**Floodway Development Permit #851-24-000641-PLNG:
COUTLER**

**NOTICE OF ADMINISTRATIVE REVIEW
Date of Notice: July 25, 2025**

RE: Incomplete application for Floodplain Development Permit review 851-24-000641-PLNG
Re-Submitted 04.17.2025 with notes in green below, along with; updated drawings dated April 4 2025, EC prepared and stamped by Dallas Esplin dated 02.25.2025, and Grading Plan dated 04.12.2025.

A-0.1
PERMIT SET
info@madisonmbi.com

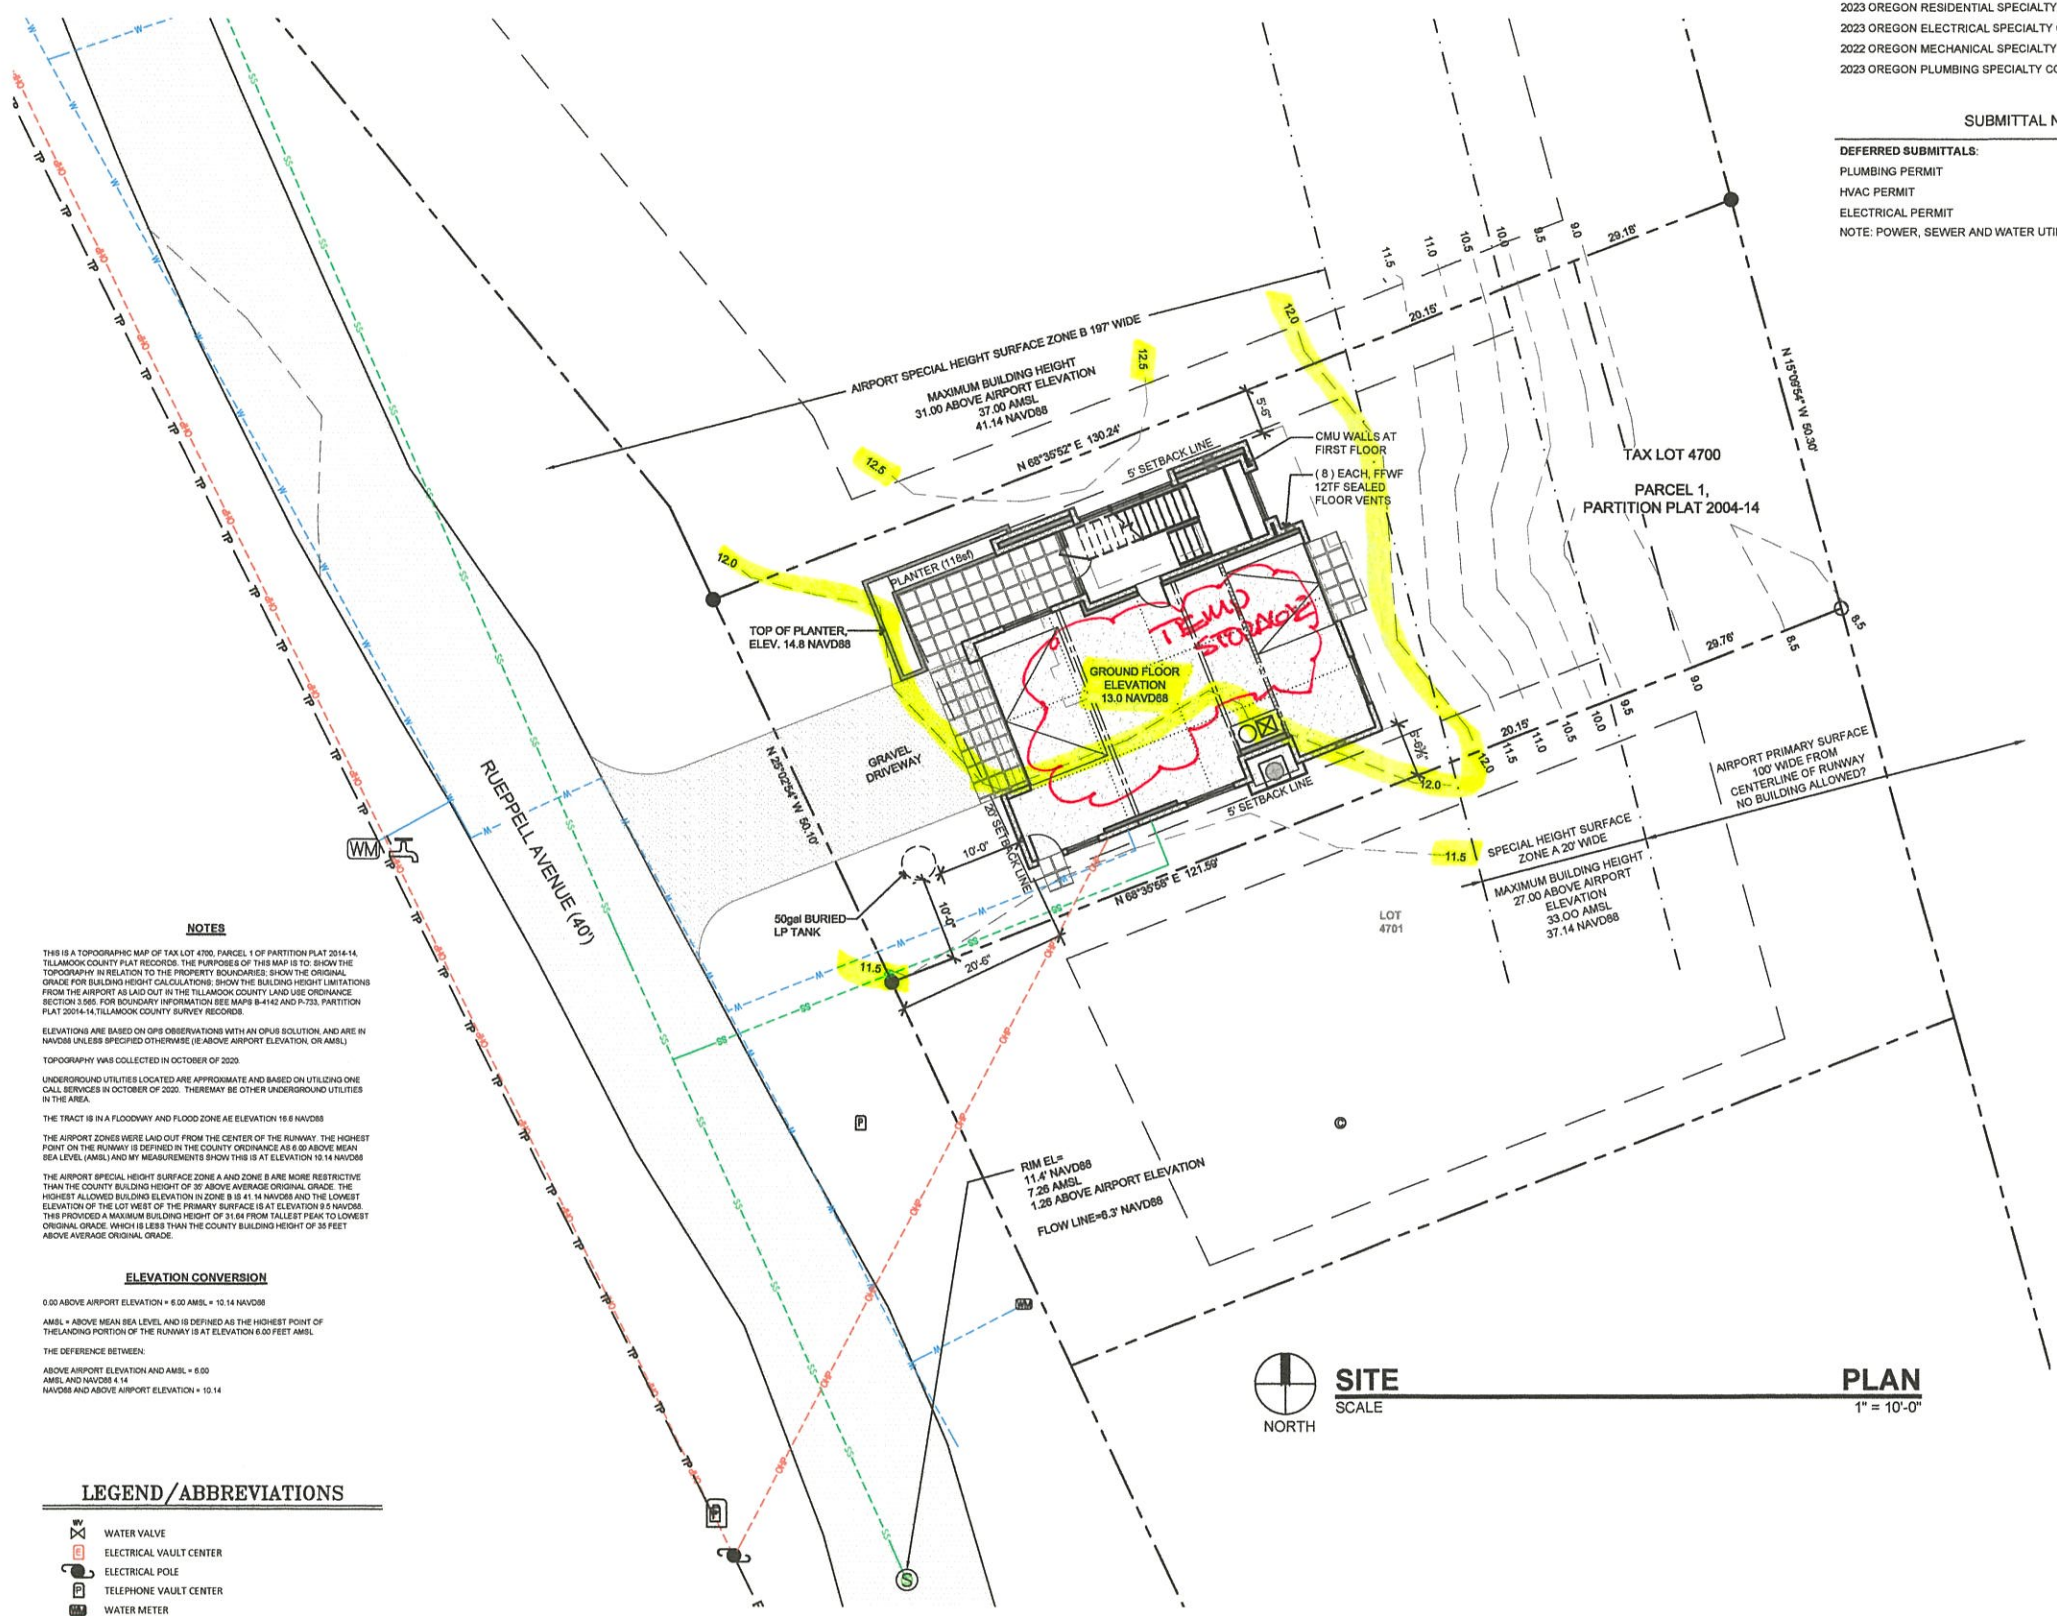
- Completed Floodplain Development permit, including:
 - Provide fill volumes in both added and removed, rather than just indicating net 0.
 - Site plan, neither no-rise analysis, concludes any values of fill volume. Unsure what is or isn't being added/removed.

- Site plan depicting location of proposed development.
 - Locations of existing trees/vegetation (indicate removal, if applicable), location and description of materials to be stored onsite during and/or after development, location and quantity of fill, grade and excavation activities.

- Grading Plan, as applicable for any fill/removal and/or grading performed on site for development.
 - Illustrate existing and proposed site elevations in plan and profile views, as necessary to describe activities.

- See attached Grading Plan dated 04.12.2025.
 - Dimensions or square footage of proposed dwelling should be contained in 'Dwelling' category.
 - This information is on sheet A-1.1

- No significant trees or vegetation on this property, just grass in the developed footprint and some scotch broom in non-disturbed areas. See grading plan dated 04.12.2025 for fill and excavation activities.

- See attached Grading Plan dated 04.12.2025, also see re-submitted drawings dated April 4th 2025 for illustrated elevations.
 - Pre and post grade must be identified.

- Indicated on sheet A0.1
 - Specify location and quantity of fill and excavation, source of fill materials & onsite disposal location(s).
 - See attached grading plan dated 04.12.2025
